# Access Compliance Report

## Public Rights-of-Way

### (Curb Ramps)

Intersection ID: 47854	Main Street: ADOBE_RD	Cross Street: CACTUS_VALLEY_RD	Location: NE
ADA ID: 6E0264C0C649	Ramp Type: PerpDiag	Initial Pass/Fail: Fail	Overall Compliance: No
		Severity Score: 10

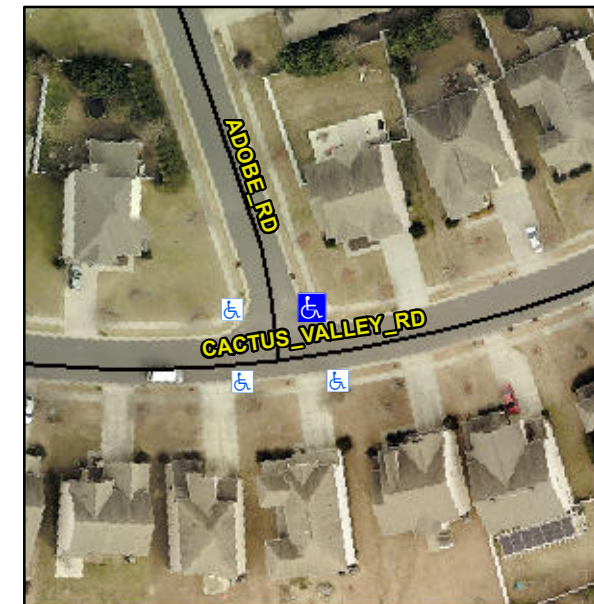
**Not Found, R304.5.1, R304.5.3**

Compliance	Description	Data	Compliance	Description	Data
N/A	Ramp Length (in)	96.0	Yes	Ramp Slope (%)	5.5
No	Ramp Width (in)	47.0	No	Ramp XSlope (%)	2.7
N/A	Flare Type LT	N/A	N/A	Flare Type RT	N/A
N/A	Flare Slope LT (%)	N/A	N/A	Flare Slope RT (%)	N/A
N/A	Flare Traversable LT?	N/A	N/A	Flare Traversable RT?	N/A
N/A	Landing Length (in)	N/A	N/A	DWS Provided?	N/A
N/A	Landing Width (in)	N/A	N/A	DWS Contrast?	N/A
N/A	Landing Slope (%)	N/A	N/A	DWS Length (in)	N/A
N/A	Landing X Slope (%)	N/A	N/A	DWS Full Width?	N/A
N/A	Landing Curb? (Y/N)	N/A	N/A	DWS Offset (in)	N/A
N/A	Shared Landing?	N/A			
N/A	Gutter Ponding?	N/A	N/A	Gutter Slope (%)	N/A
N/A	Gutter Lip Ht (in)	N/A	N/A	Gutter X Slope (%)	N/A
N/A	Painted X Walk1?	No	N/A	Painted X Walk2?	No
	X Walk 1 Direction	To W		X Walk 2 Direction	To S
N/A	X Walk 1 Width (in)	N/A	N/A	X Walk 2 Width (in)	N/A
	X Walk 1 Slope (%)	2.1		X Walk 2 Slope (%)	0.2
	X Walk 1 X Slope (%)	0.6		X Walk 2 X Slope (%)	1.3

**Remove & Replace Curb Ramp With Two New Directional Ramps or Equivalent.**
